<b>TITLE</b> TO ELIMINATE DATA ERRORS DUE TO CROSS TALK FROM TEMPERATURE & WRITE COMP. PCBA TO R/W PCBA			PIB NO. DK3065	
PRODUCT LINE:	TAPE DISK FORMATTER <input checked="" type="checkbox"/>	EQUIPMENT CHANGED Temp. & Write Comp 103977	MODEL SERIES AFFECTED D3000	EFFECTIVE DATE 9/1/76

**TITLE** TO ELIMINATE CROSS TALK FORM TEMPERATURE AND WRITE  
COMP PCBA

PIB NO.  
DK3065

Figure 1

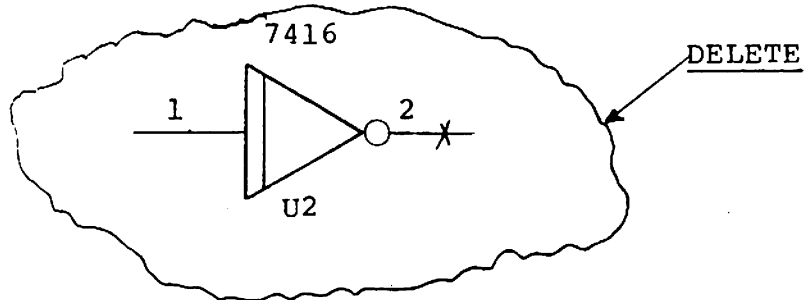
1. Add jumper from U2 pin 1 to U2 pin 6.
2. Add jumper from U2 pin 2 to U5 pin 7.

Sheet 1 in spare  
logic elements

Figure 2

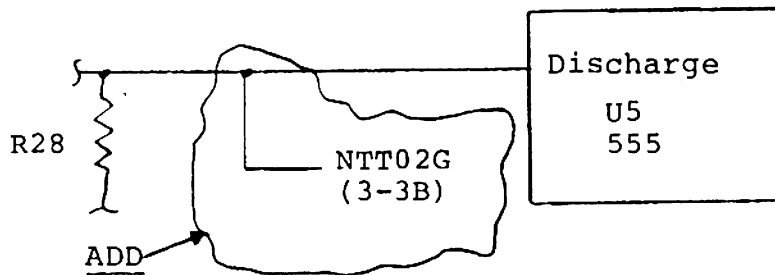
Sheet 3 zone 7-B

Figure 3

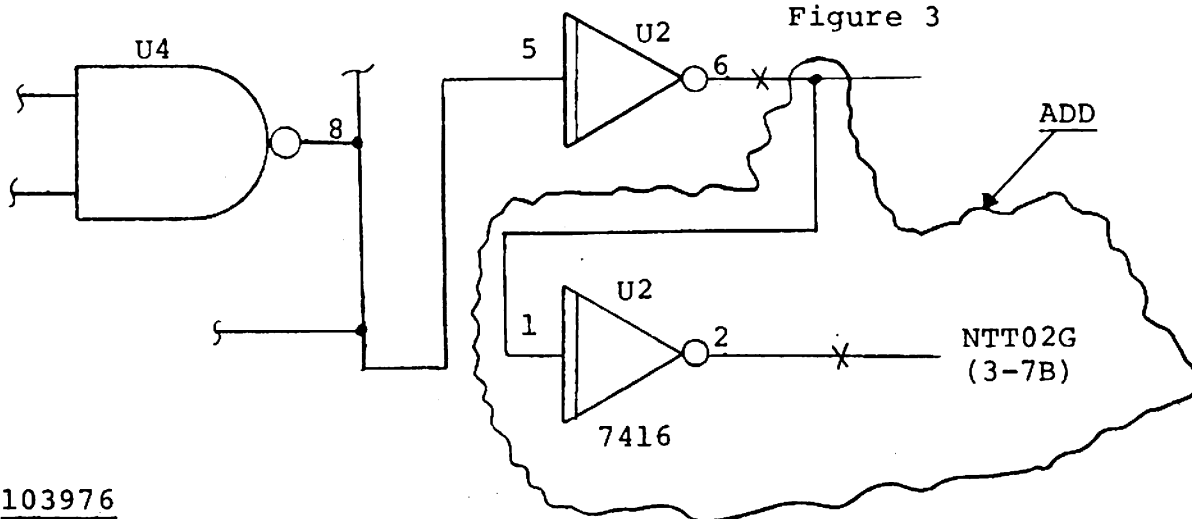
Sheet 3 Zone 3/4-B

FIGURE 4

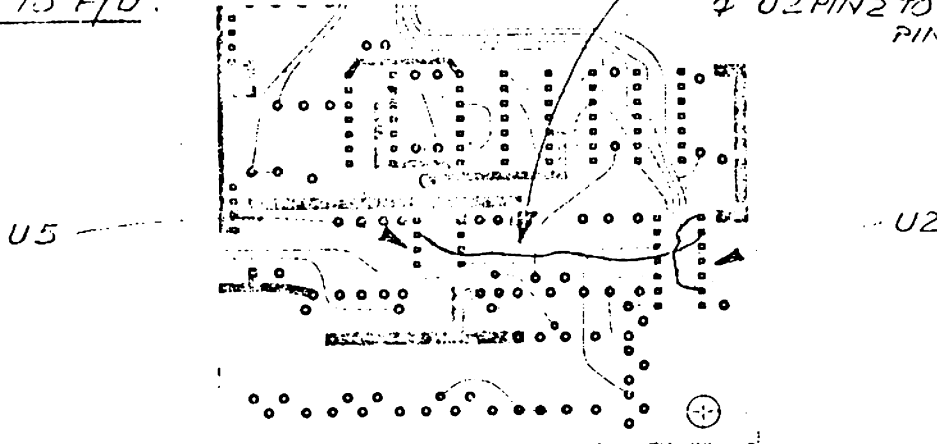
ADD JUMPER  
691 - 6030  
U2 PIN1 TO U2 PIN6  
U2 PIN2 TO U5  
PIN 7
